Work Order ID 127202

Item Name: Quick Release Heli-Utility-Basket™

DART SERVICE INSTRUCTION

TO AMEND INSTALLATION INSTRUCTIONS D350-607-3 Rev.D,
INSTALLATION INSTRUCTIONS D350-607-4 Rev. C AND
INSTRUCTIONS FOR CONTINUED AIRWORTHINESS ICA-D350-607 REV. 6
REF TCCA STC: SH94-14
REF FAA STC: SR00213NY
REF EASA STC: EASA.10016996
REF BRAZILIAN STC: 2007S03-03/-04/-05/-06

FIGURE 1: INSTALLATION OF D4775-041 FWD STRUT

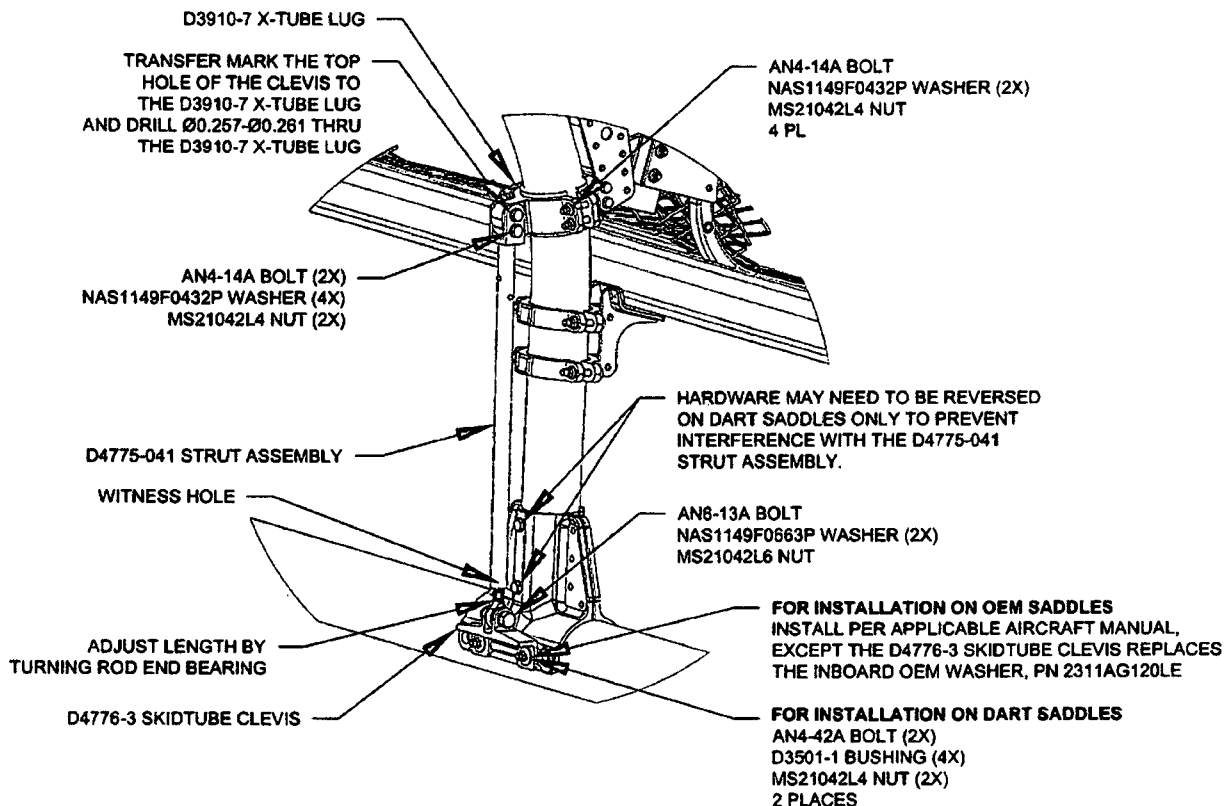
- 3.1 Substitute the Forward Lower D3910-5 X-Tube Lug with the D3910-7 X-Tube Lug as shown in Figure 1.
- 3.2 Install the forward D4775-041 Strut Assembly. Transfer mark from the upper hole on the clevis of the D4775-041 Strut Assembly to the D3910-7 X-tube Lug and drill thru the lug $\varnothing 0.257$ - $\varnothing 0.261$ as shown in Figure 1. Touch up chemical conversion coating per MIL-DTL-5541. Check the witness holes located at the bottom end of the D4775-041 Strut Assemblies to ensure that the thread from the rod end extends past the witness hole.
Torque MS21042L4/-4 nuts to 50-70 in-lbs (5.7-7.9 N-m). Torque MS21042L6/-6 nuts to 160-190 in-lbs (18.1-21.5 N-m).
- 3.3 Complete the installation in accordance with Installation Instructions D350-607-3 Rev. D or D350-607-4 Rev. C.
